# Hernando County

# Planning & Zoning Commission

## Agenda

## TITLE
CP 1490384 Parkway Townhomes

UTILITY PLAN

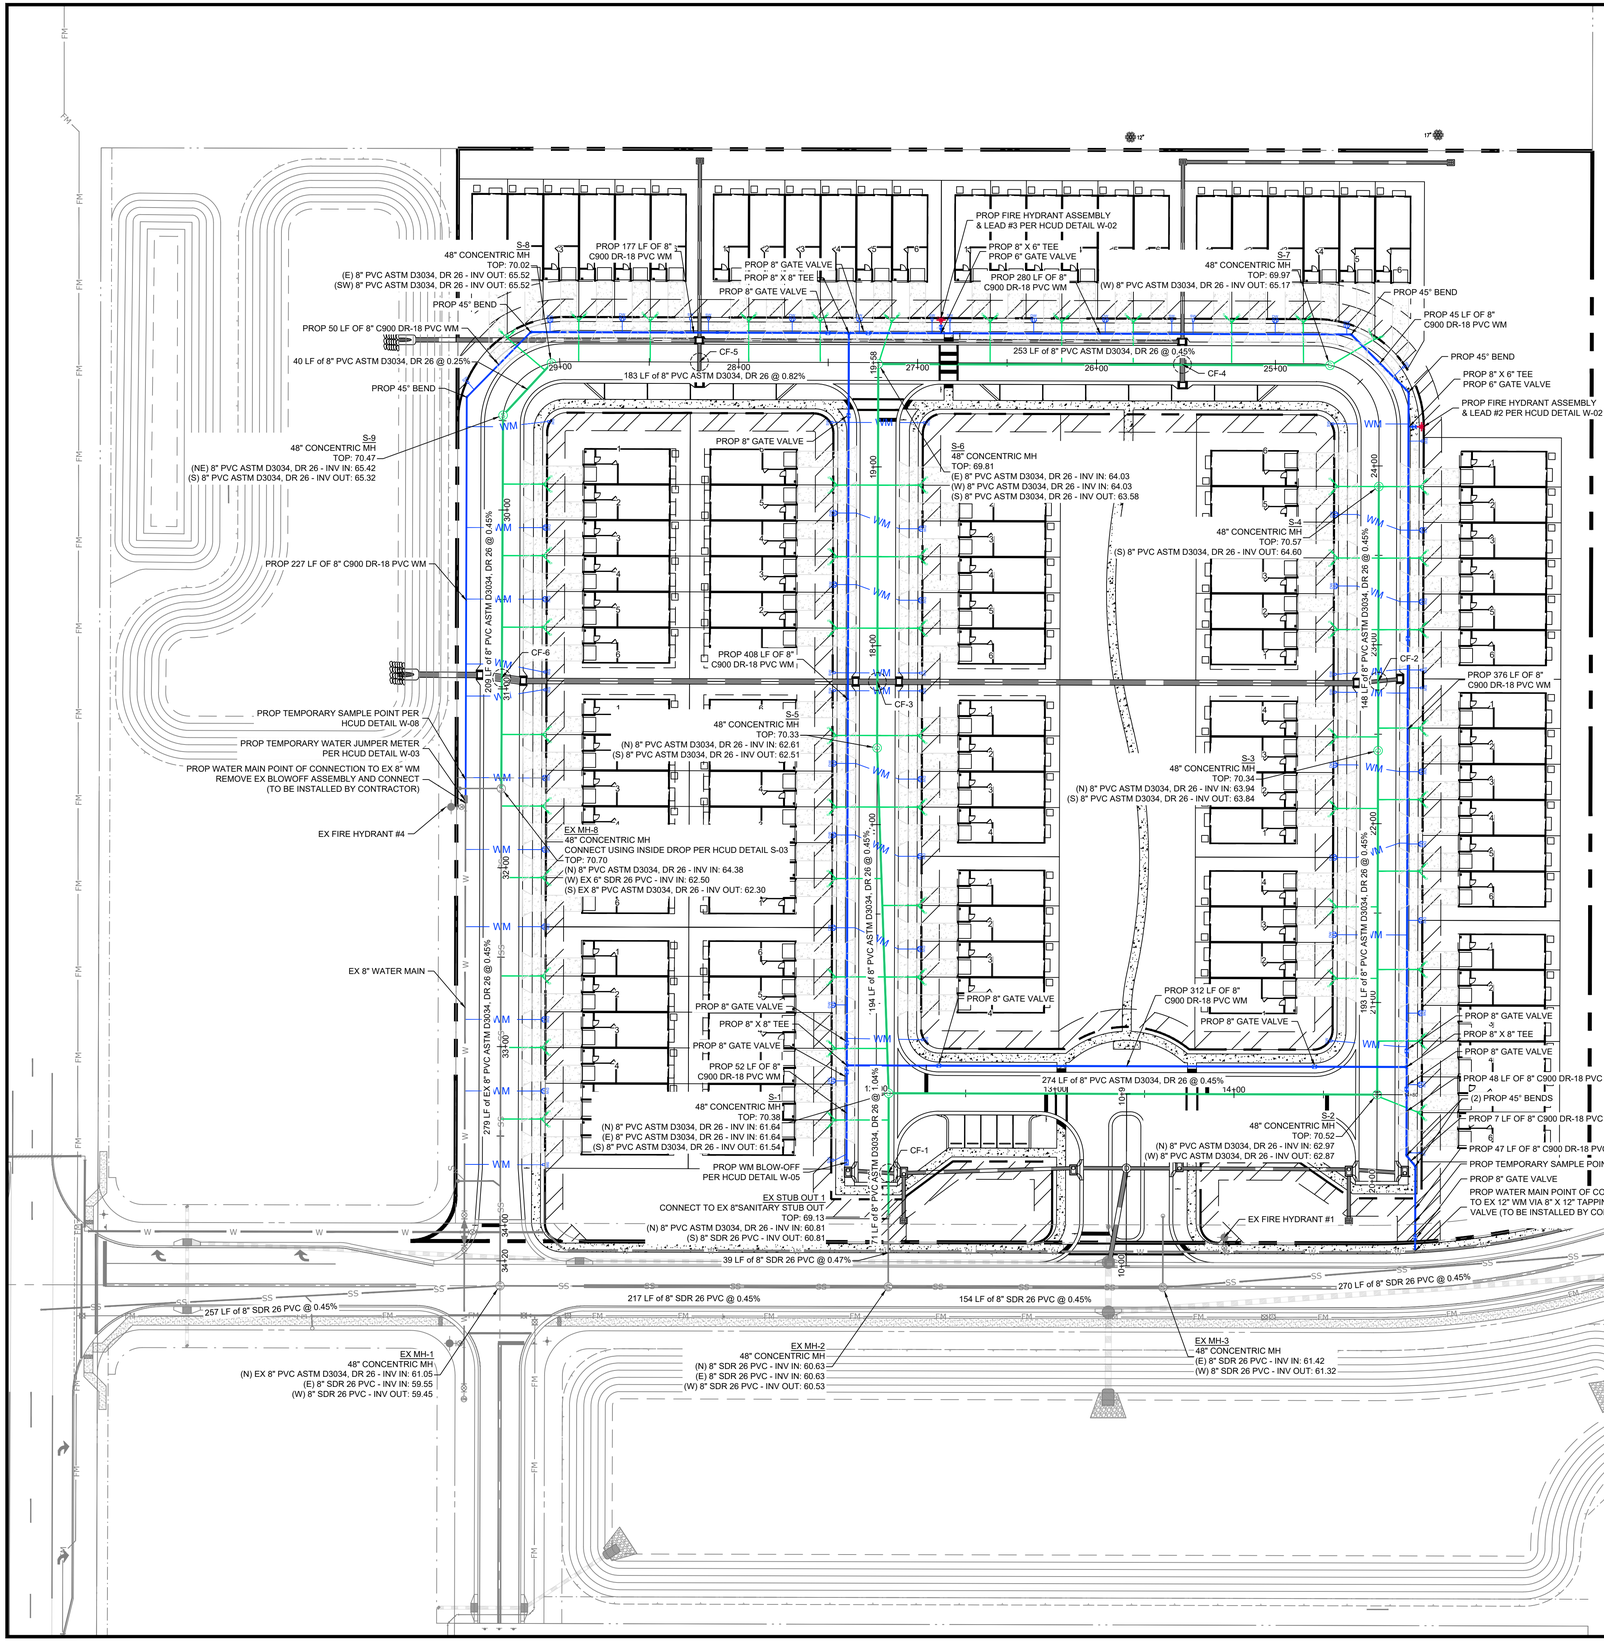
will be privately maintained. Show the proposed wastewater pump station site(s) as dedicated tract(s) sized per HCUD detail S-10 (June 2023 version) on the construction drawings.

8. The developer shall revise the water and wastewater capacity analysis as follows:

- Page 3 of 22: The hydraulic analysis report states, the proposed pressure network was added to Hernando County's WaterGEMs model, however there is no data from the 2025 PDD Scenario in this report. Revise as necessary.

- Page 20 of 22: The capacity analysis shows a reservoir table and pump table, however if the proposed network was added to Hernando County's WaterGEMs model, these tables should not be here.

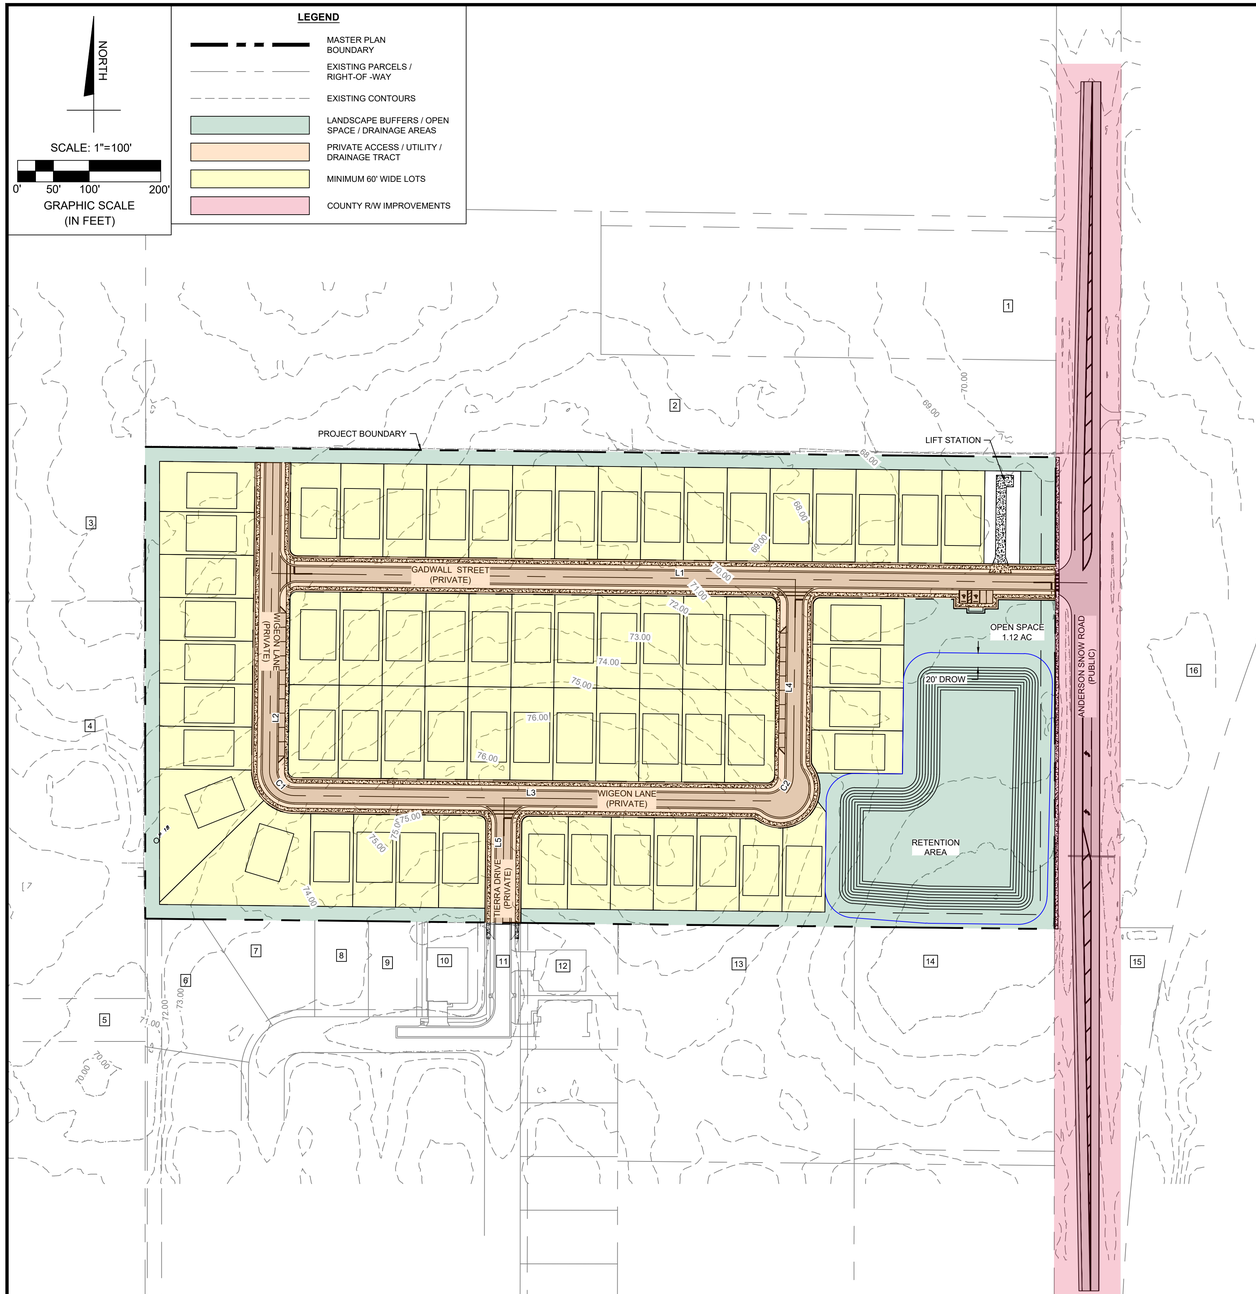
will be privately maintained. Show the proposed wastewater pump station site(s) as dedicated tract(s) sized per HCUD detail #S-10 or #S-15 (June 2023 version).

7. The Developer shall make the following modifications to the Utility Capacity Analysis and resubmit at the time of construction drawings:

- **Water:** Further analysis using HCUD's model with proposed elevations, once determined, and final hydrant locations added to the model will be required as part of the construction drawings capacity analysis submittal.

- **Wastewater:** Additional analysis will be required as part of final engineering to design the proposed pump station. The pump station shown in the lift station capacity analysis does not meet HCUD specifications. Revise the pump station design as necessary prior to submitting the construction drawings capacity analysis submittal.

9. The petitioner shall revise the pump station tract to meet HCUD detail #S-10 (exceeds 60-foot depth).

# Attachment B – EX-2 Preliminary Floodplain Compensation Plan

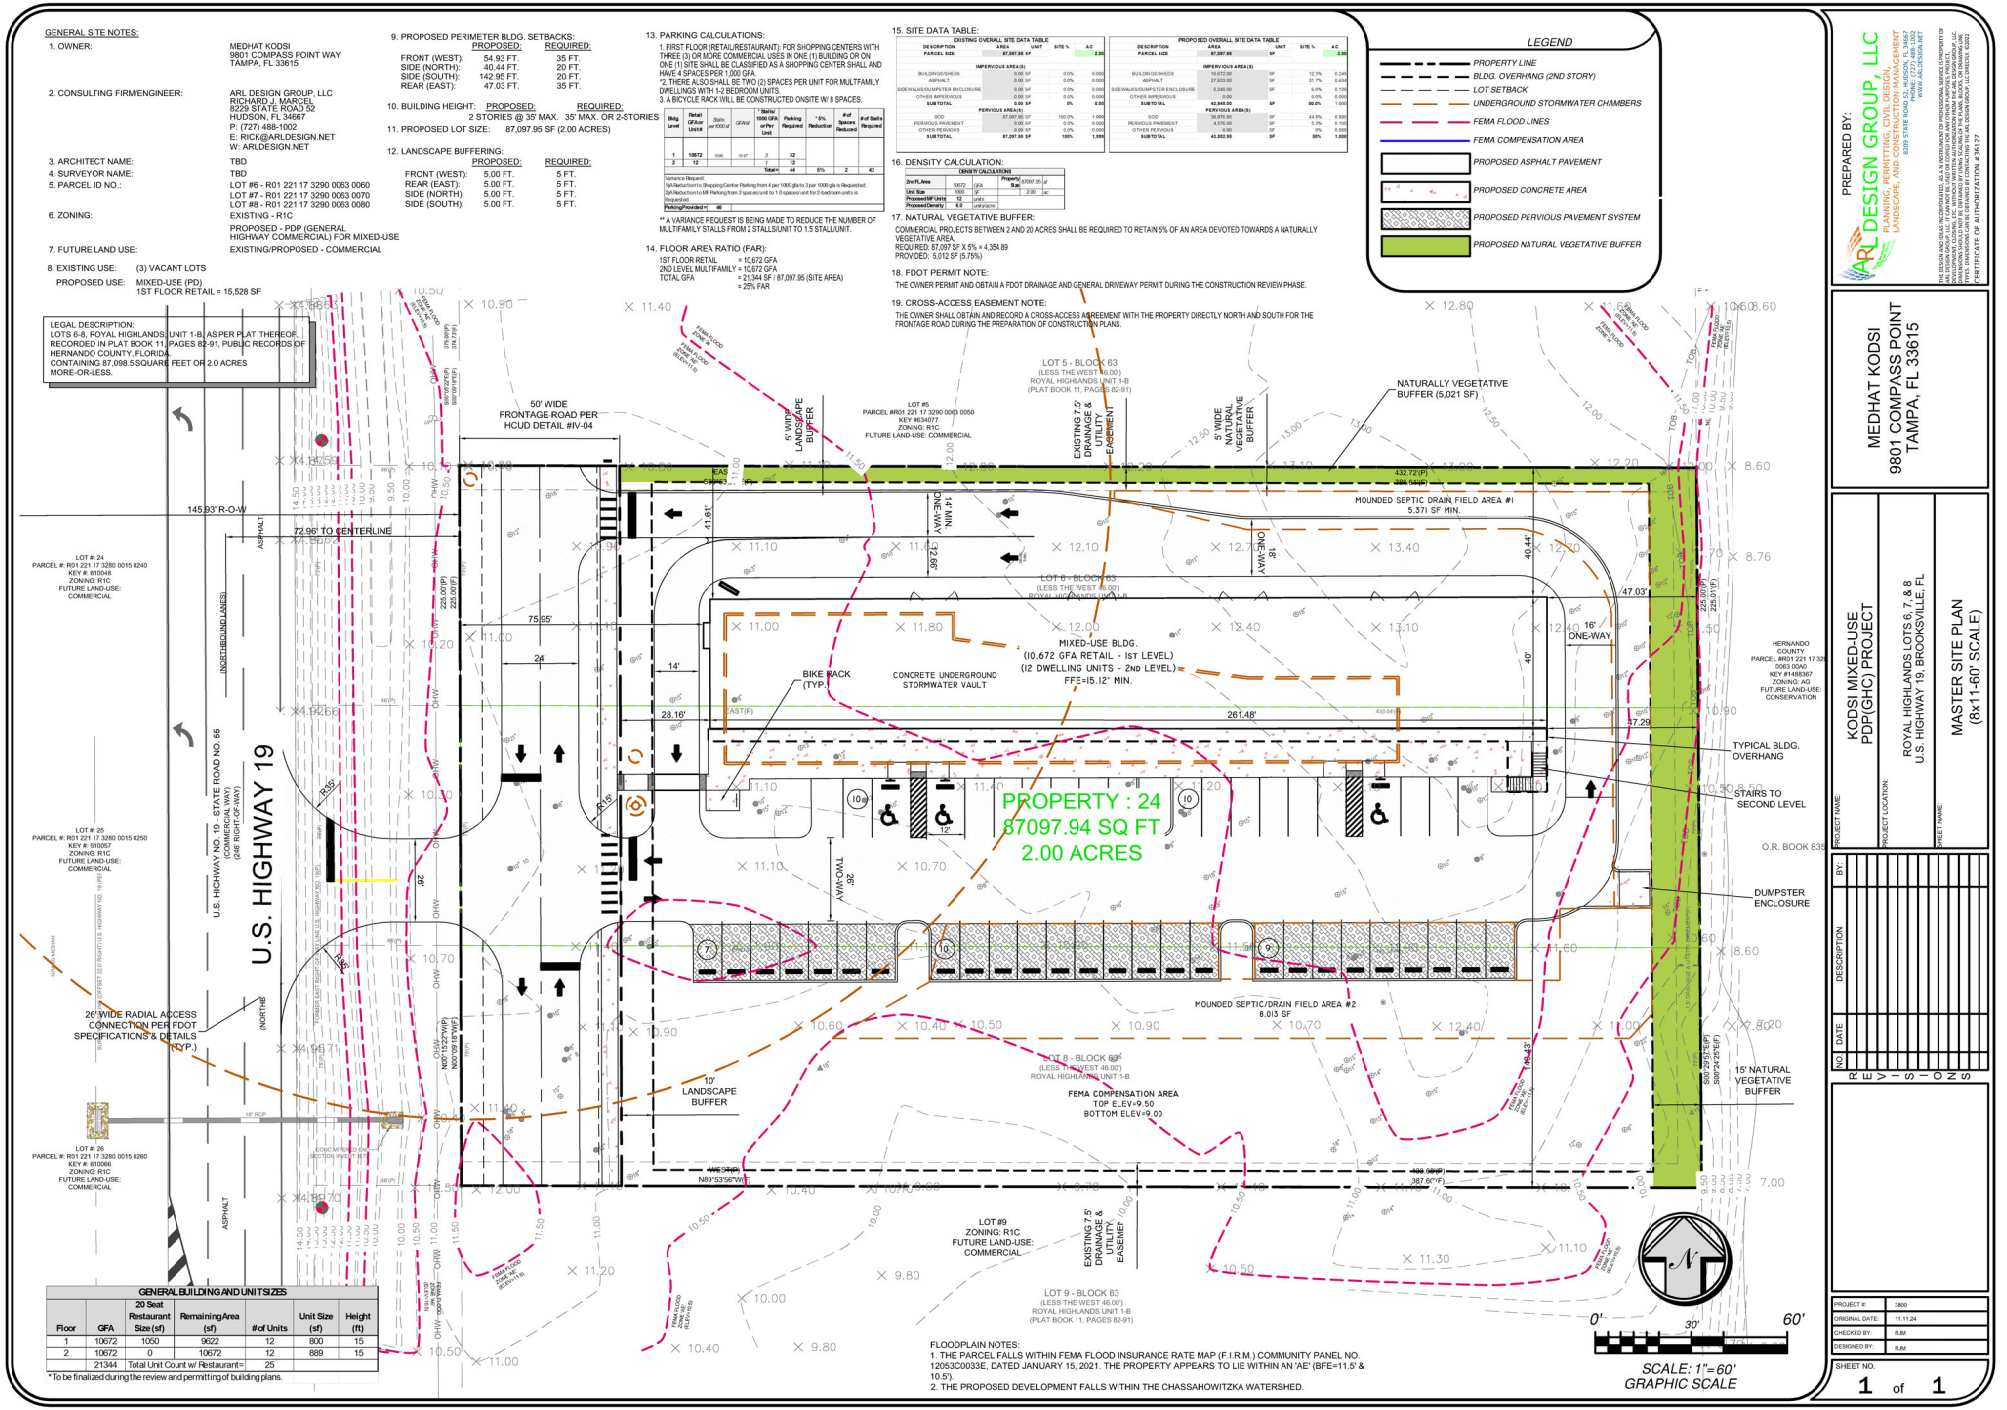
3. The septic system requires a Florida Licensed Professional Engineer design due domestic sewage flow more than 2500gpd and the size of the drainfield. A note has been placed on sheet EX-1 and we will provide a sealed design during the permitting phase.

Setbacks notes and permitting with the FDEP has been placed on sheet EX-1.
7. Calculations in estimated sewage demand table correct. See note in row 2. No comments on peak or total demand as this is the remit of the engineer.

Calculations are added to sheet EX-1. Each MF unit will be between 800 and 100 sf (max.).
8. Not sure if there is a retention pond but the setback to the well is 75ft. Also setback to the septic system is 50ft or 75ft depending on when the lot was created. Prior to 1/11972 the setback is 50ft. Call me discuss if necessary, as it also depends if DRA designed to hold water less than 72hours.
